Proposed Code Change

Code Title Indiana Residential Code		Edition 2009
Section number and title FIGURE E3901.4		Page 682
Proponent Charlie Eldridge	Title Consultant	
Address 551 Grassy Ln., Indianapolis, IN 46217		Phone (317) 370-3444

Delete Figure E3901.4 and substitute the following drawing which was extracted from the 2008 Edition of the NFPA NEC Handbook:

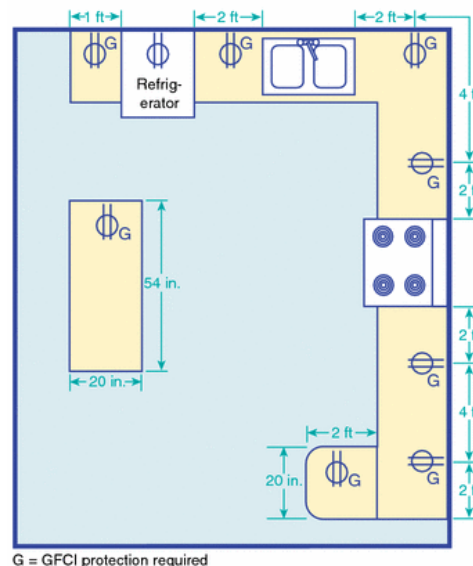
Figure E3901.4 in the IRC is misleading with 1' and 2' dimensions. It looks like receptacles are required to be more closely spaced than the text requires and will lead to confusion and misapplication of the code.
